DOCUMENT 00 90 00
ADDENDUM

ADDENDUM: 2

PROJECT: WESTERN TECHNICAL COLLEGE
SPARTA PUBLIC SAFETY TRAINING SIM CITY
11177 COUNTY HWY 1
SPARTA, WISCONSIN 54656
PROJECT NO. 25039

FROM: HSR Associates, Inc
100 Milwaukee Street
La Crosse, WI 54603
(608) 784-1830

4 COMMERCIAL UNIT " B " LIGHTING PLAN
1/4" = 1'-0"

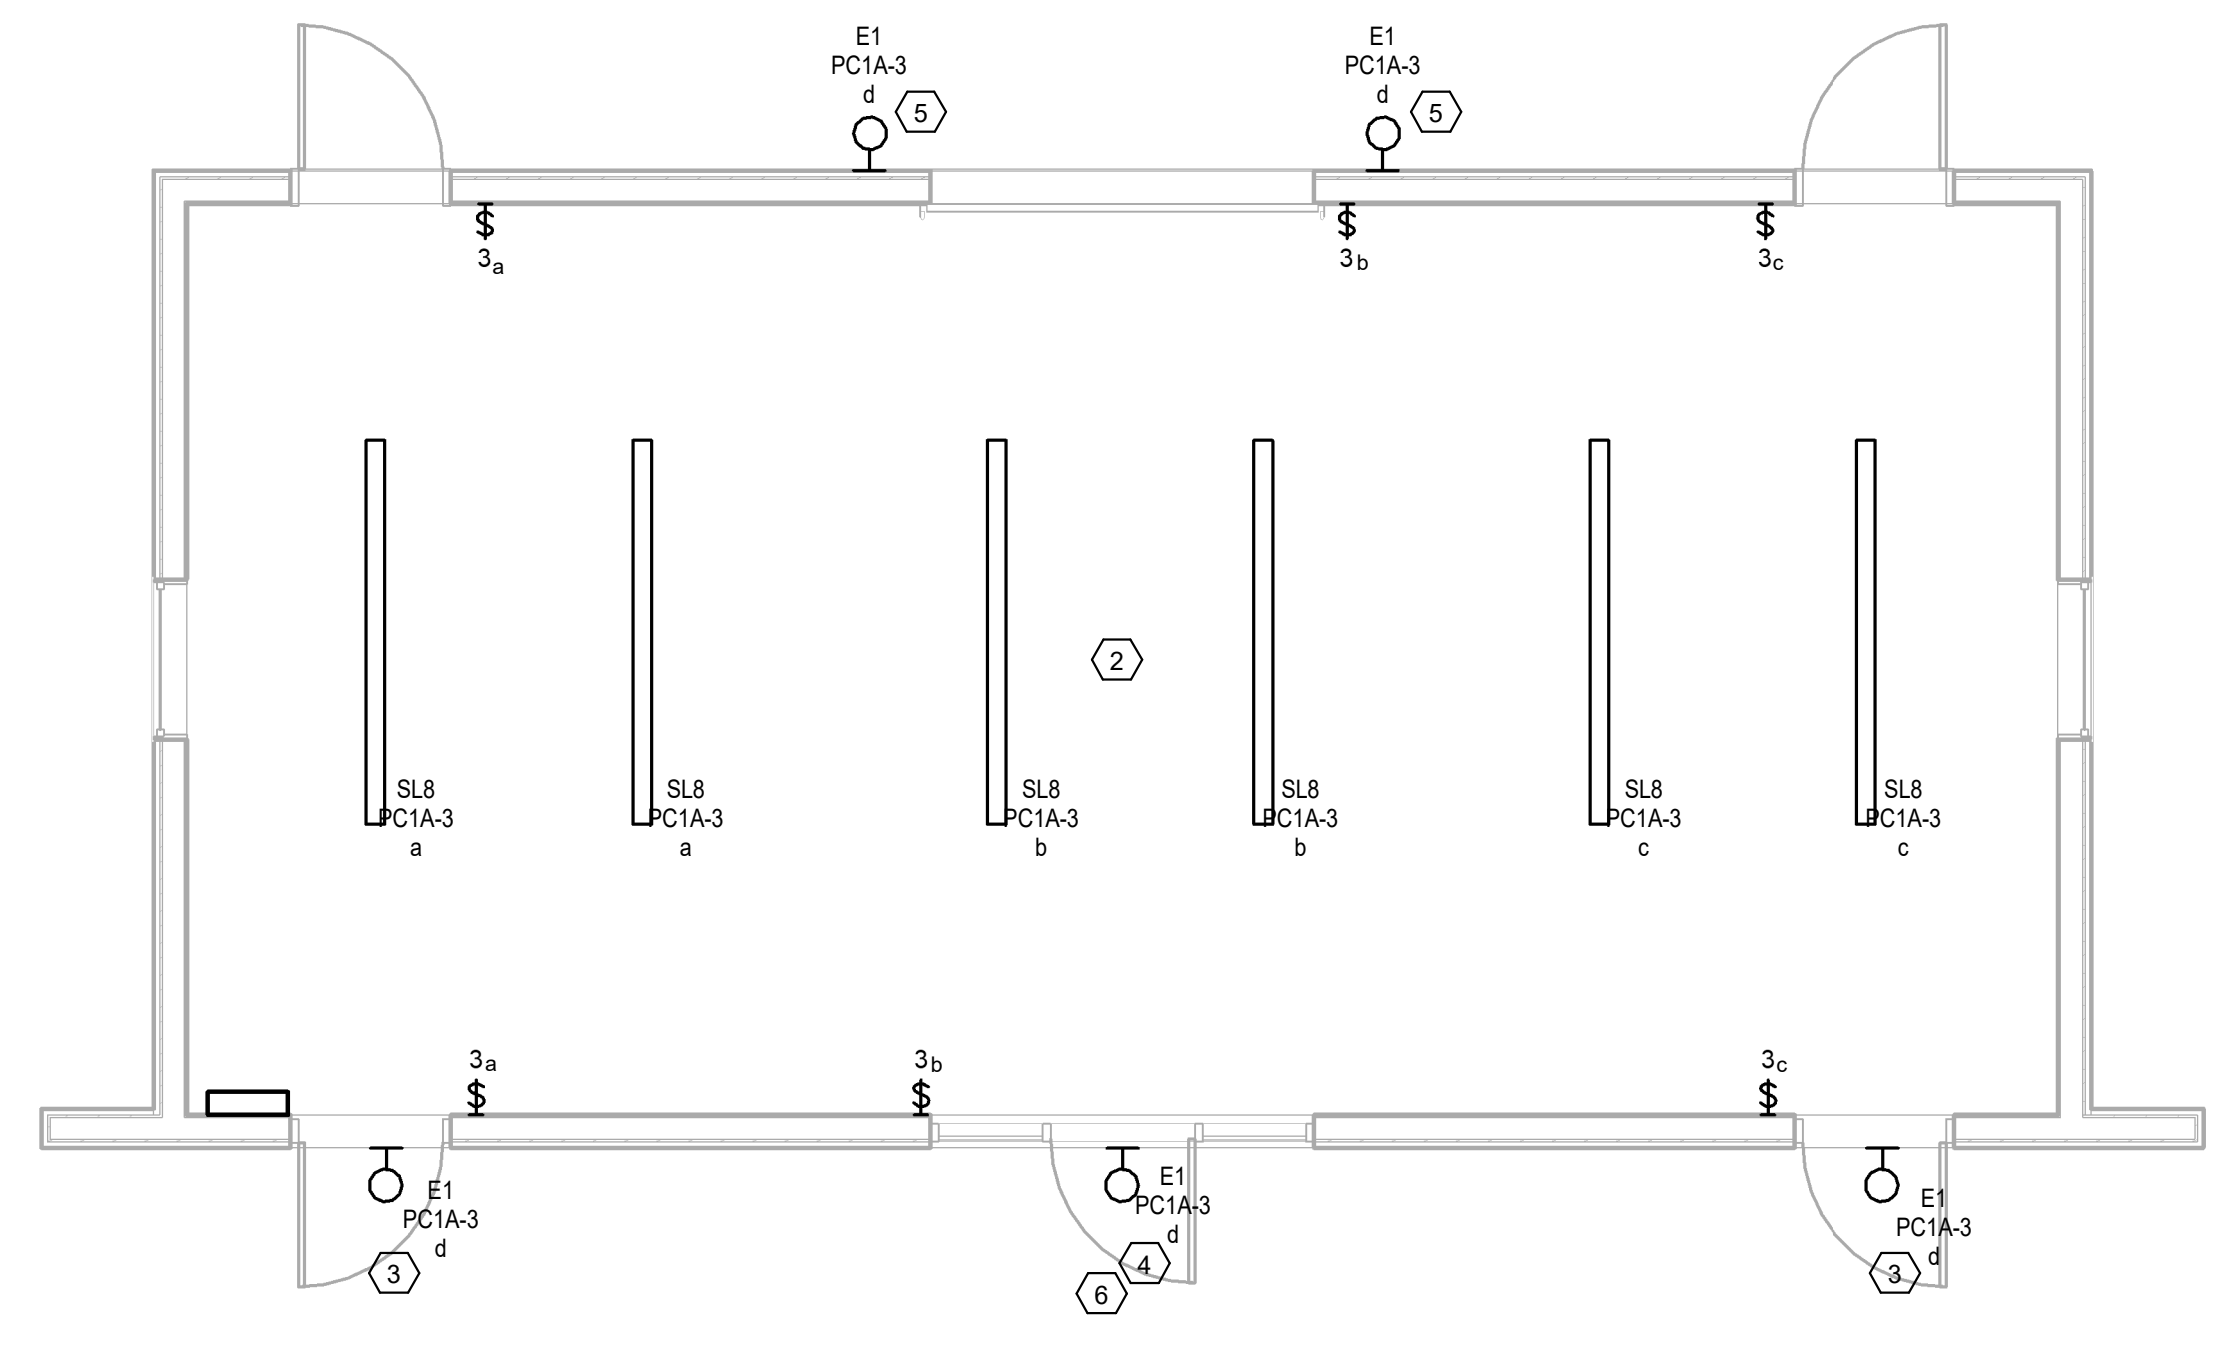
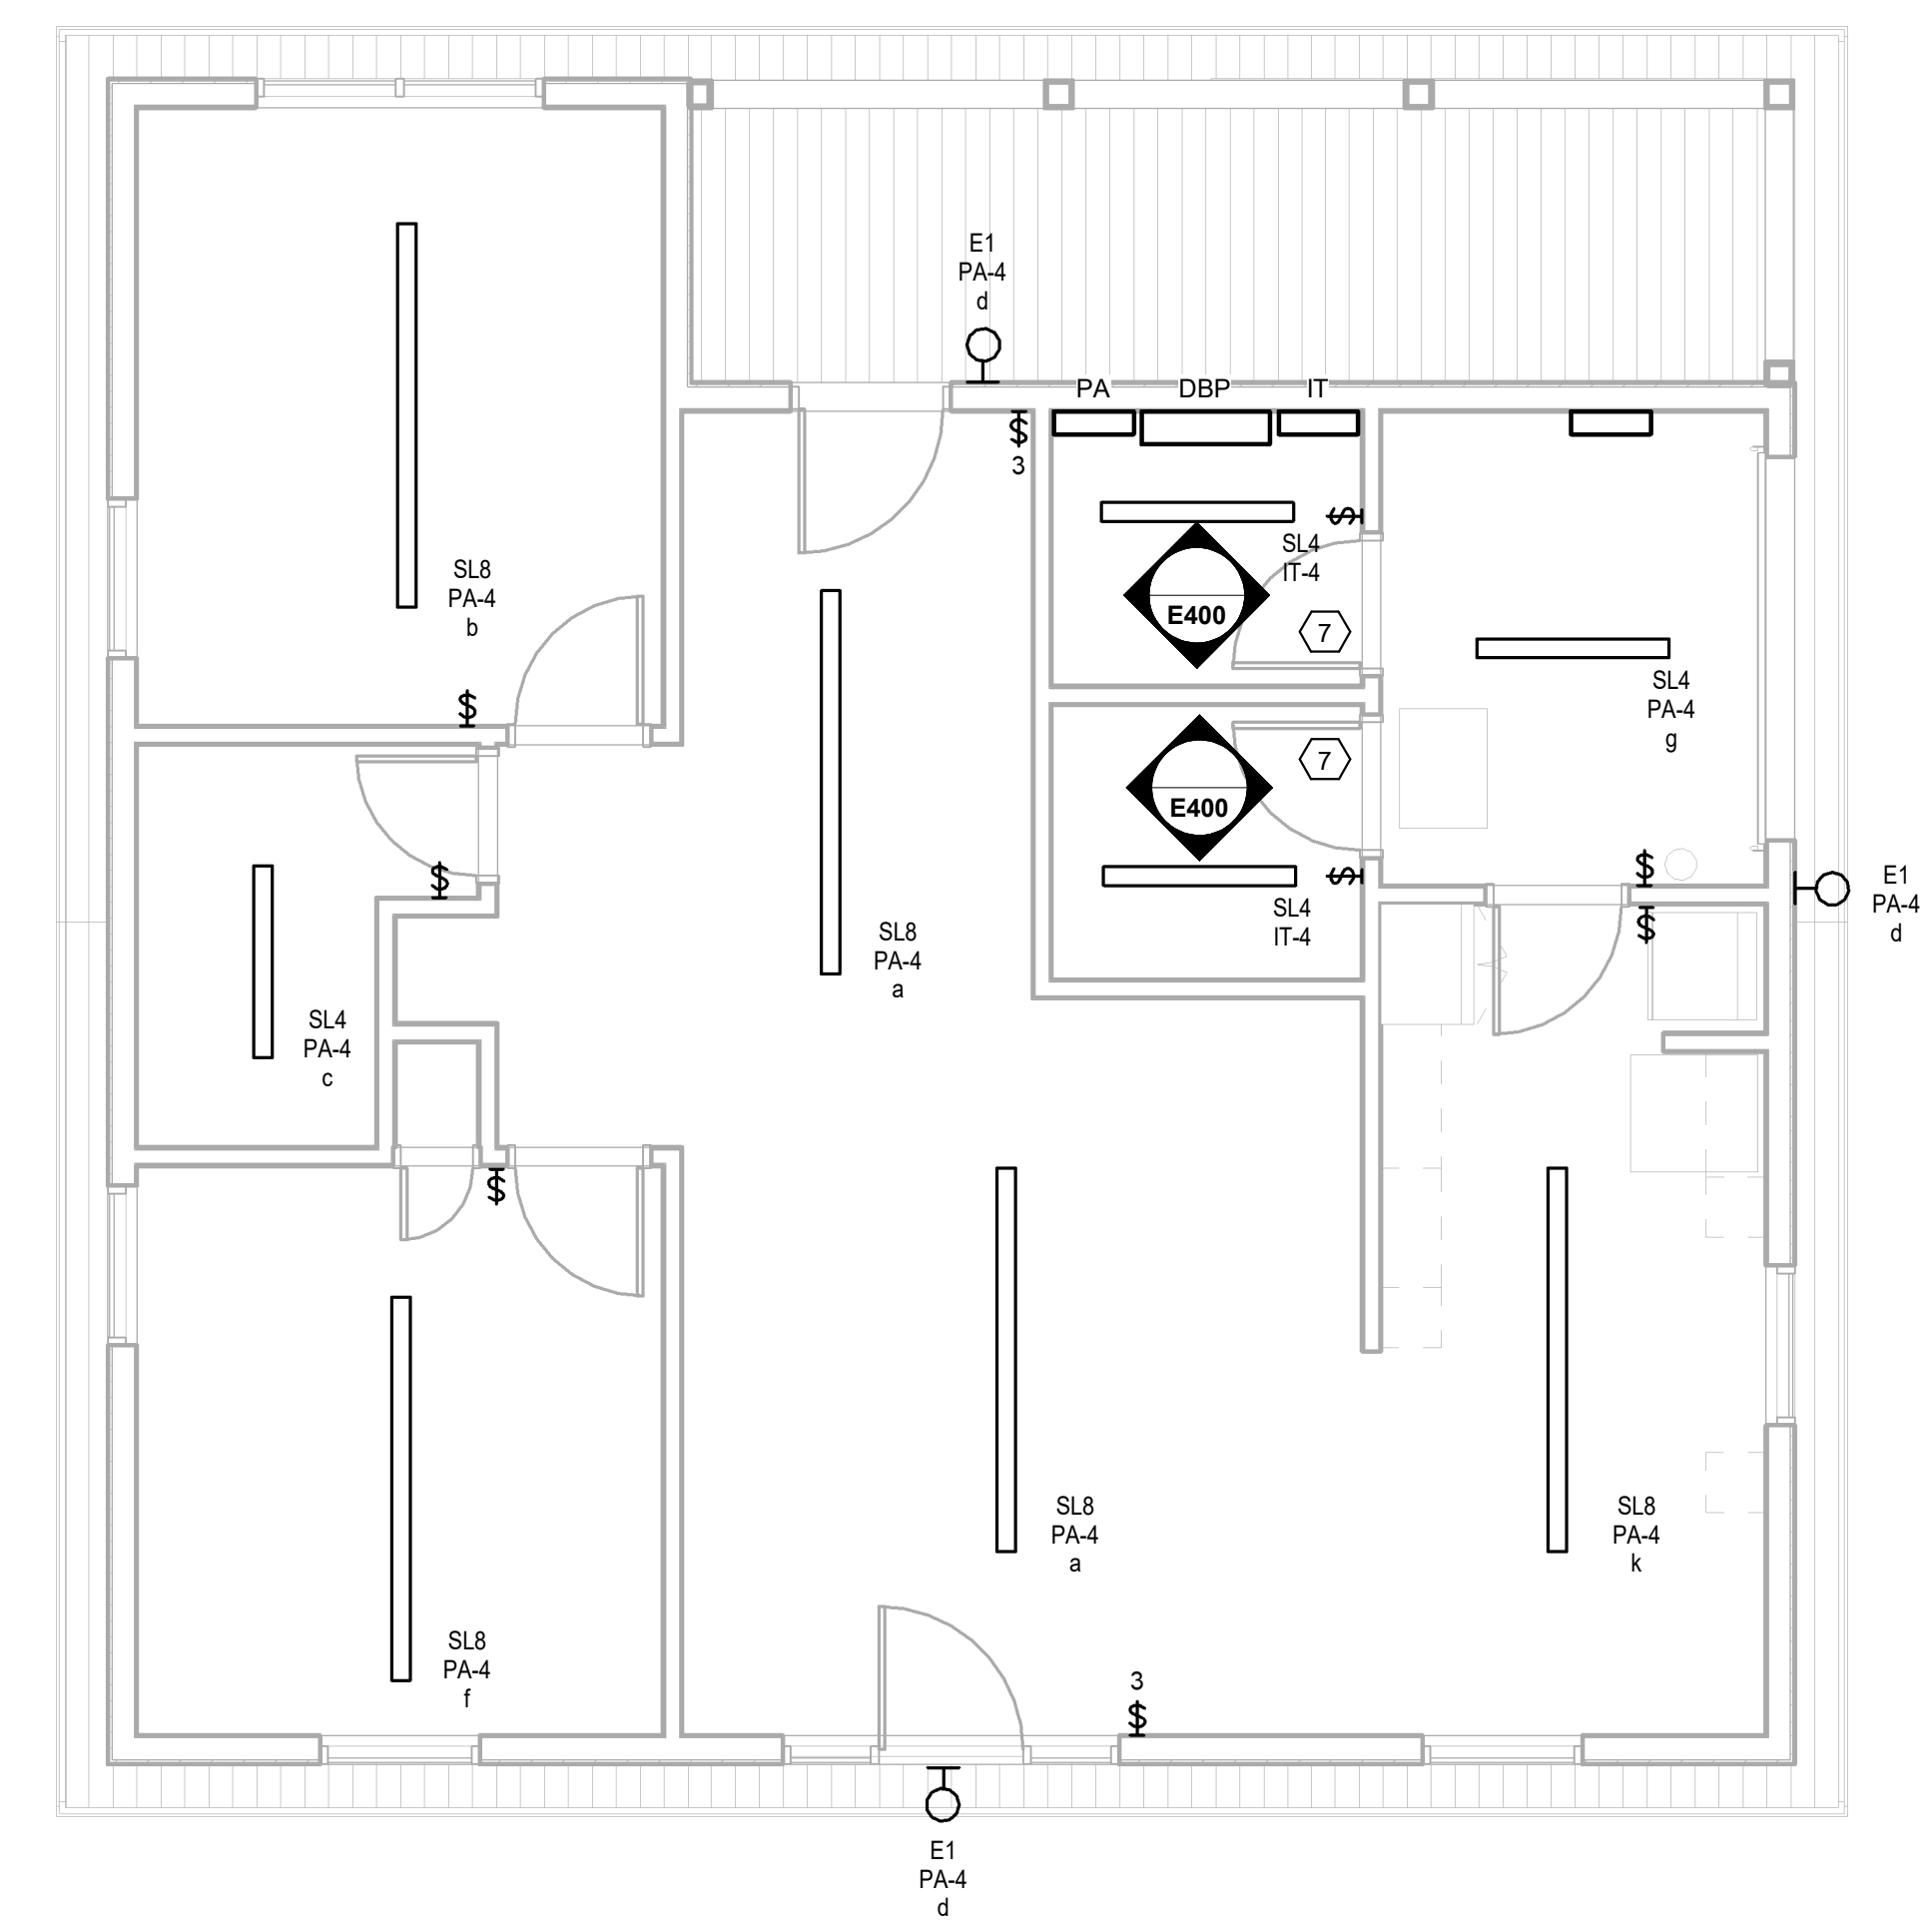
- a. See the revised sheet included in this addendum. Disregard the previous version.
- b. Added detail 4/E100 regarding Commercial Building B.
